**NY Power  
Authority**

Crescent Hydroelectric Project, FERC Project No. 4678-052  
Vischer Ferry Hydroelectric Project, FERC Project No. 4679-049  
Response to ISR Comments and Submission of Revised Study Plan

## Crescent Project Flow and Water Level - July, 2020

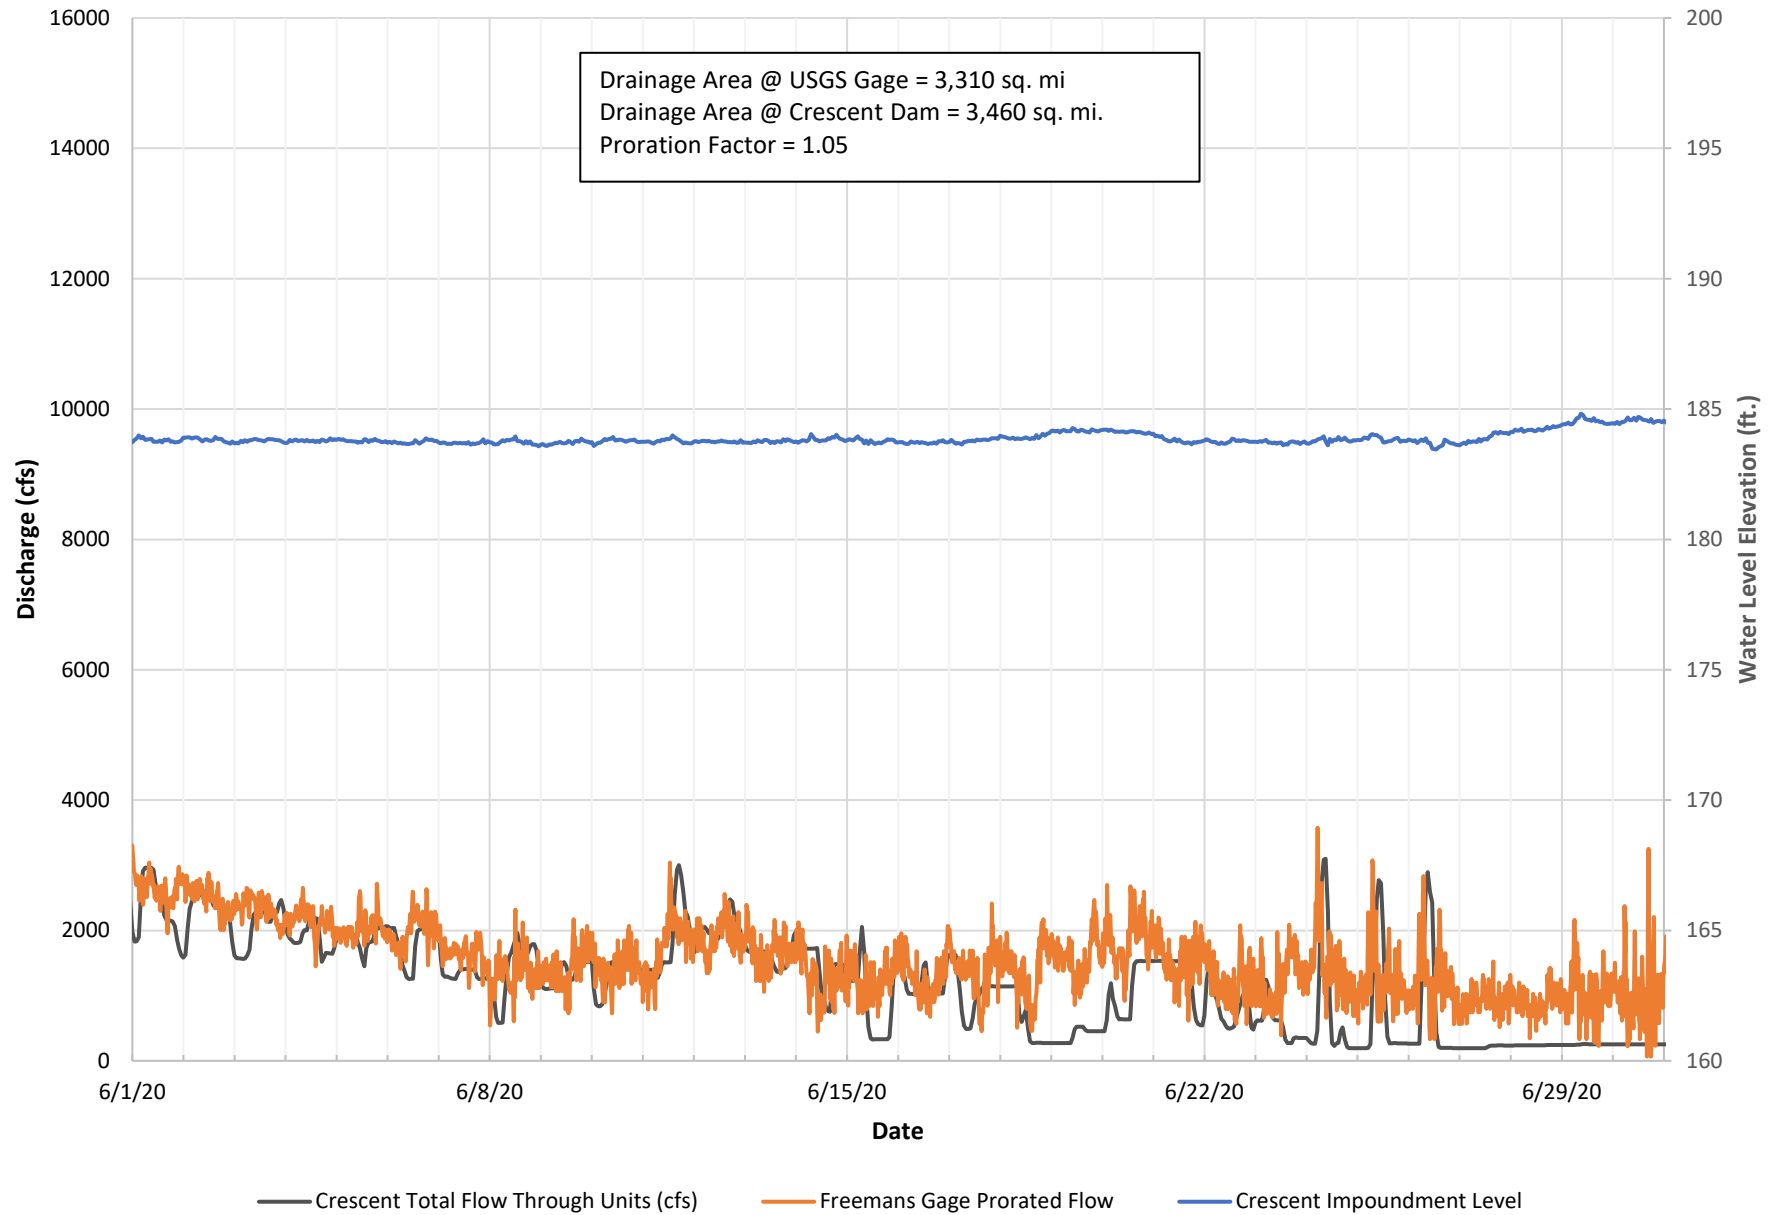
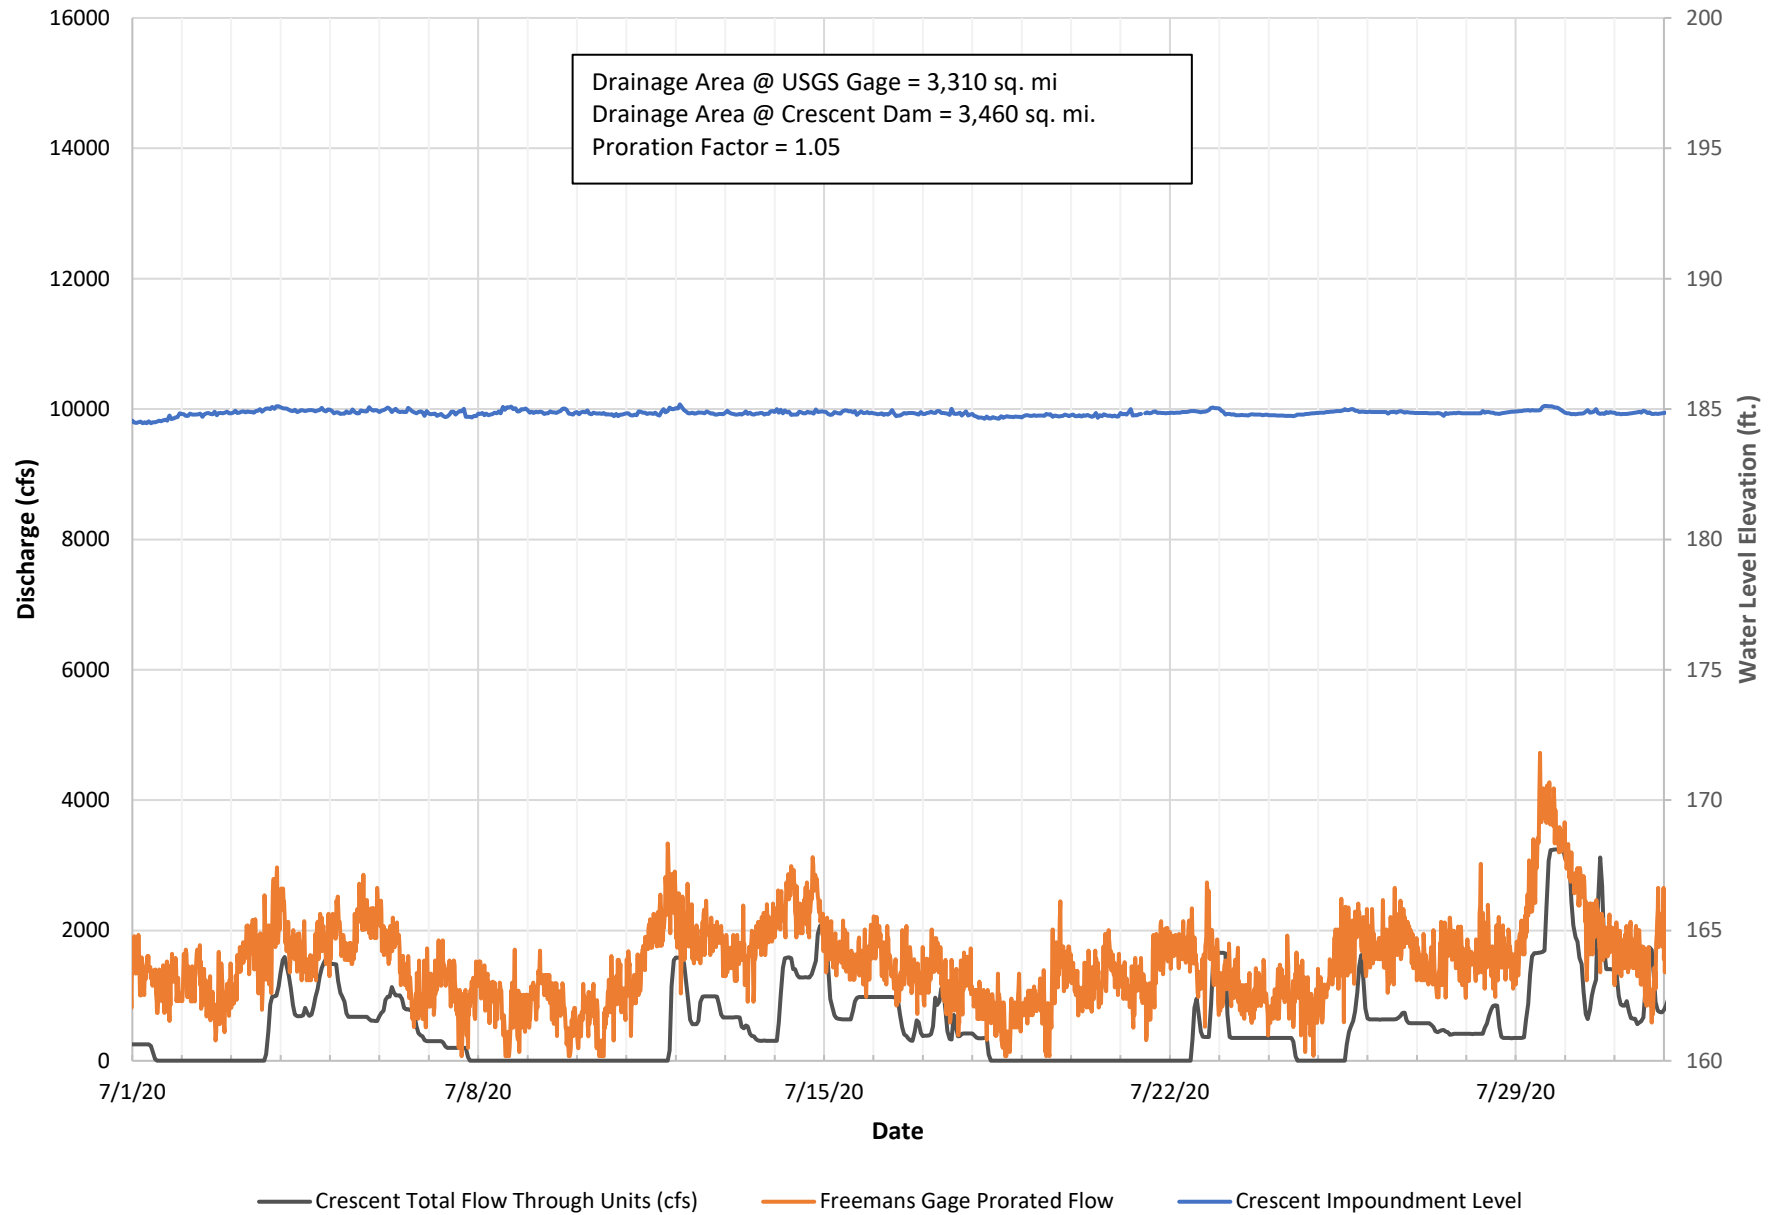
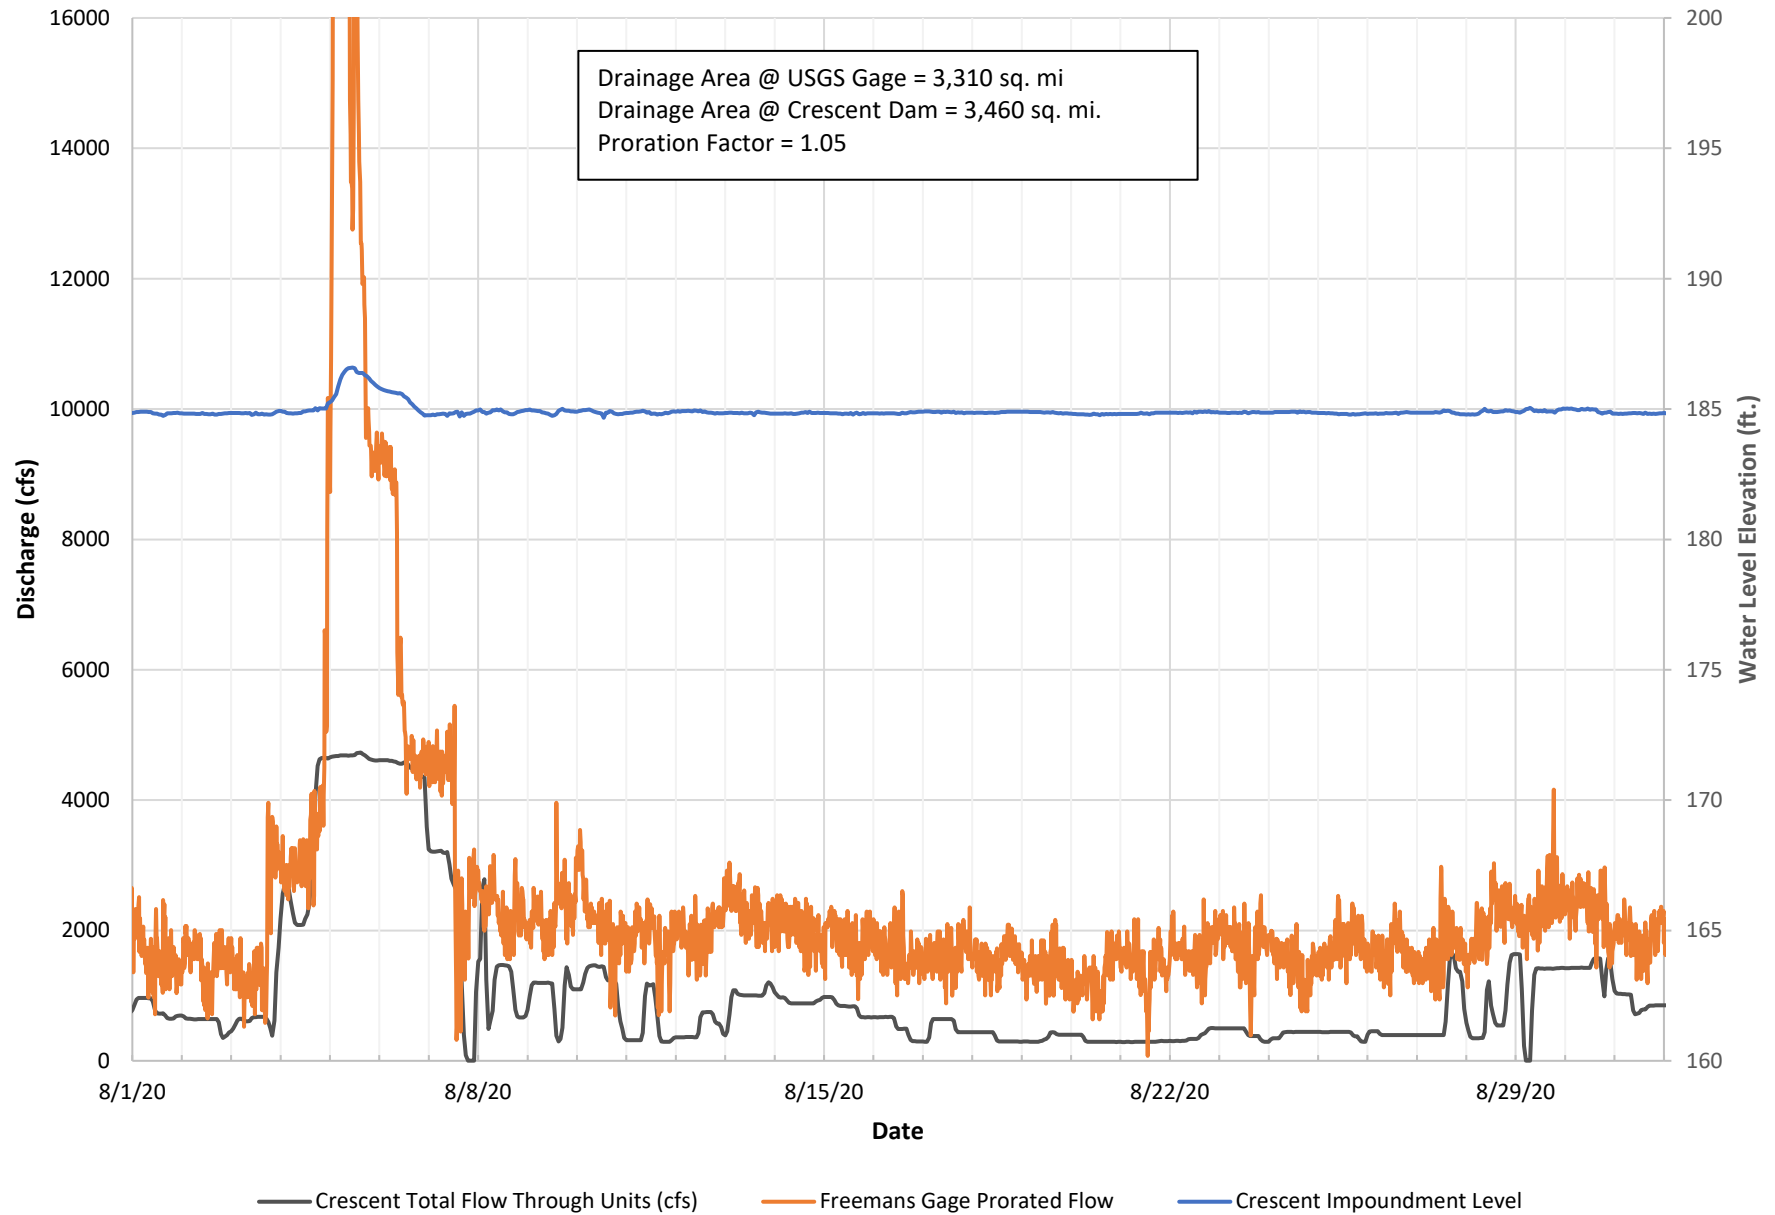
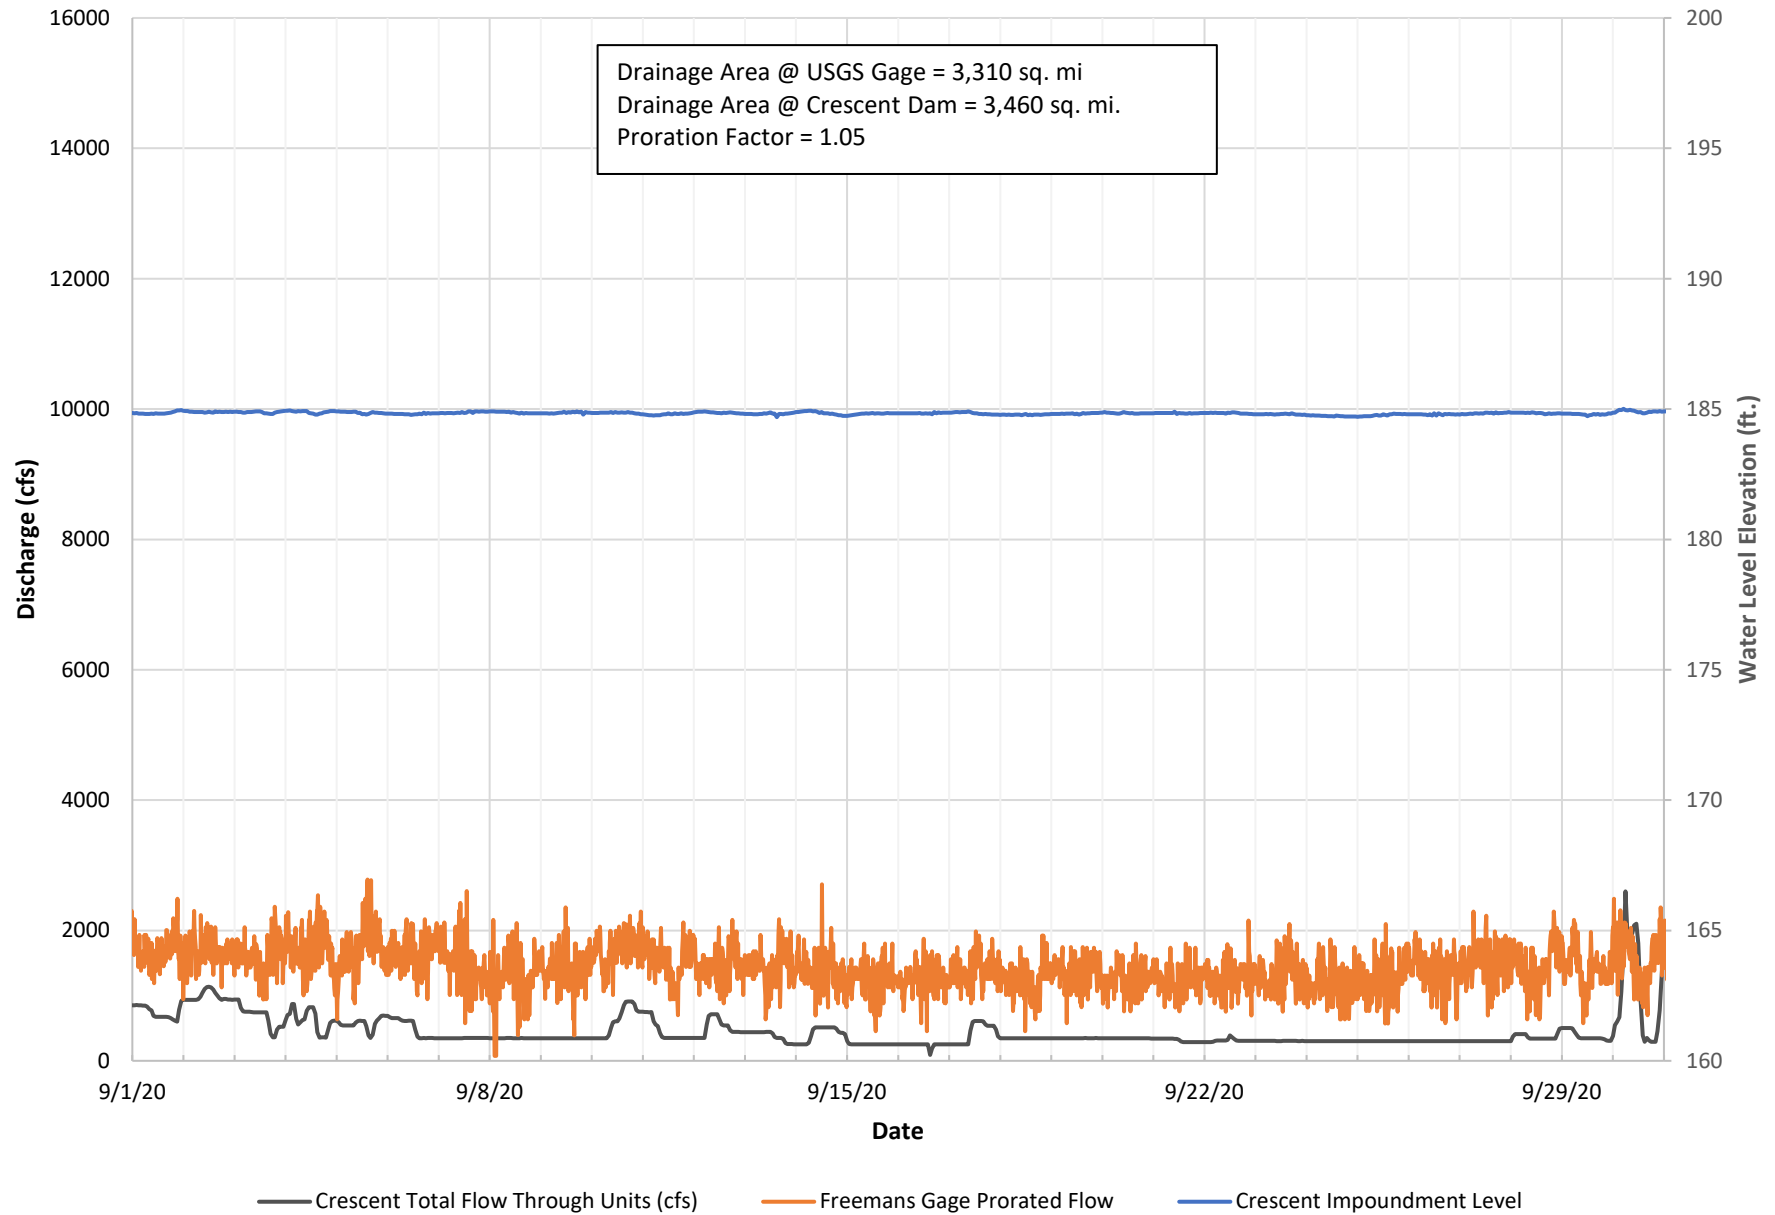
**Comment 2:** NYSDEC (4/16/2021) requests that the Power Authority graph the total prorated flow that passes the Projects with generation flow included. NYSDEC notes that this will provide a more complete understanding of flows at the Projects, how they are being utilized, and confirm that the minimum flows are also being provided.

**Response 2:** The Power Authority has developed the requested graphs of prorated flows (based on drainage area) at the Vischer Ferry and Crescent Projects, using the flow data from the upstream USGS gage (no. 01354500) on the Mohawk River at Freeman's Bridge (Attachment 2). The drainage area at the USGS gage is 3,310 sq. mi. and proration factors used were 1.02 for the Vischer Ferry Project and 1.05 for the Crescent Project. Also shown on the flow graphs is elevation data for the two Project impoundments. As shown, impoundment fluctuations were minimal throughout the study period, demonstrating that the Projects were operating as run-of-river throughout the study season.
